Russell Vale Colliery

UNDERGROUND EXPANSION PROJECT RESIDUAL MATTERS REPORT

for
Wollongong Coal Limited
June 2014

**PREFERRED PROJECT
RESIDUAL MATTERS
REPORT**

Figure 1 illustrates the mine plan for the UEP (to scale and with geo-referencing) to show the location of LW7 relative to Cataract Creek.

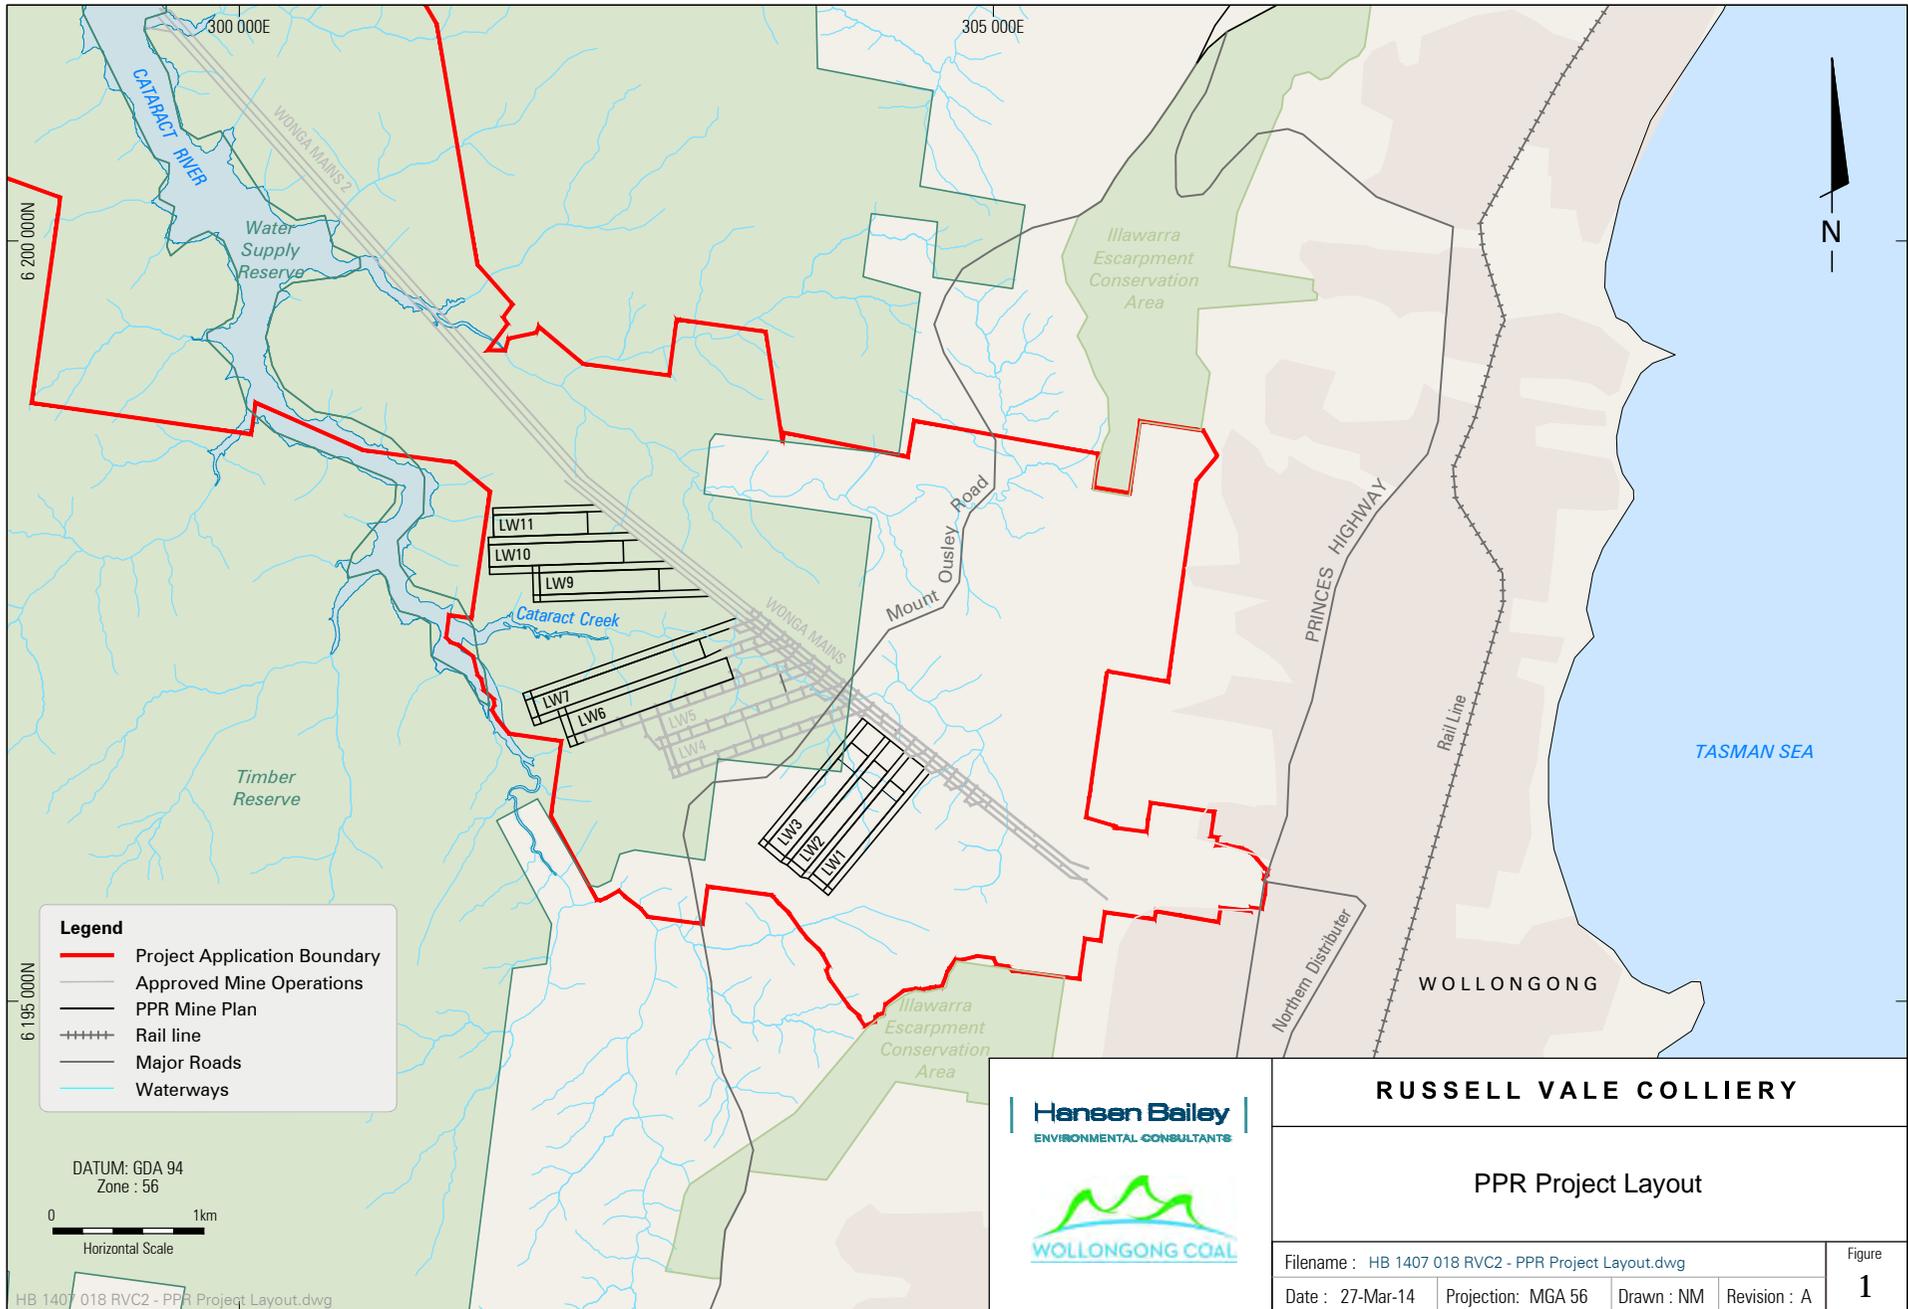
Ref	Regulator	Issue	Where Addressed
1.	DP&E	<p>2.1 Changes to the Mine Plan</p> <p>The new mine plan is presented in Figure 4 of the PPR however no scale is shown and it is not georeferenced. This mine plan was positioned with respect to the MGA by overlaying the EA and PPR mine plans of Figure 4 of the PPR onto a georeferenced drawing of the EA mine plan, and scaling it until a visual match was obtained between the two versions of the EA mine plan. The result is shown in Figure 1. This process allowed positioning of Cataract Creek (not shown in Figure 4 of the PPR) with respect to LW7 of the PPR mine plan. However, the positioning error from this process is unknown.</p>	Figure 1
